Office Action Summary

10/517,321

DETAILED ACTION

Karube teaches a multiple piezoelectric crystal microbalance device (see entire document, particularly Fig.'s 1-3, 6, 7, 14, and 16). For clarity, the following annotated Fig.'s 6 and 7 of Karube are used to refer to different components of the claimed invention.

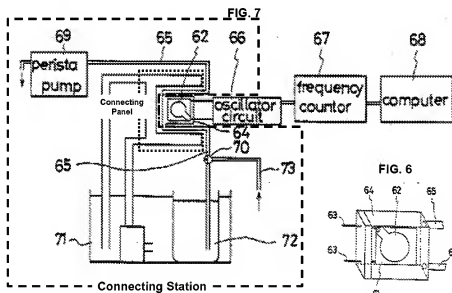
The device of Karube includes a connecting station (see annotated Fig. 7 above) for receiving and an individually operating array of piezoelectric crystal microbalances (column 9, lines 12-22). The connecting station of Karube includes a connecting panel having an array of cell connecting receptors (see annotated Fig. 7 above), each cell connecting receptor comprising a receptor connector portion for automatic mating operative engagement with a cell connector portion of a piezoelectric crystal

microbalance flow-through cell (Fig. 6) upon plugging the flow through cell into the connecting station. Each receptor connector portion comprises a pair of electric connecting ports (reference elements 63 in Fig. 6) for communication with a power and measurement means (Fig. 16 and column 5, lines 23-49) for oscillating a piezoelectric crystal (reference element 60 in Fig. 6) carrying electrodes (reference element 62 in Fig. 6 and column 5, lines 27-30) in a cell compartment (reference element 64 in Fig. 6) of one operatively engaged flow-through cell and for measuring oscillating characteristics of the piezoelectric crystal; and a pair of fluid connecting ports (reference elements 65 in Fig. 6) for communication with flowing means for flowing a solution (column 5, lines 39-49).

Although Karube's device includes a connecting station with a pair of fluid connecting ports, the device of Karube differs from the instant claims in that that pair of connecting ports provide flow for the plurality of piezoelectric crystal microbalance flow-through cells instead of having a pair of fluid connecting ports associated with each of the receptor connecting portion for individual piezoelectric crystal microbalance flow-through cells.

Karube further fails to teach a multiple piezoelectric crystal microbalance device, wherein the individually operated piezoelectric crystal microbalances are electrostatically and electromagnetically shielded from each other and further comprising grounding means for electrical grounding of the flow solution and the test solution aliquot to the cell compartment of each of the flow-through cell. The current specification discloses that electrostatic and electromagnetic shielding can be provided by enclosing an individually operated piezoelectric crystal microbalance with a metal (p14, lines 6-10).

In addition, Karube differs from the claimed invention in that Karube fails to teach that the plurality of piezoelectric crystal microbalance flow-through cells is individually detachable.
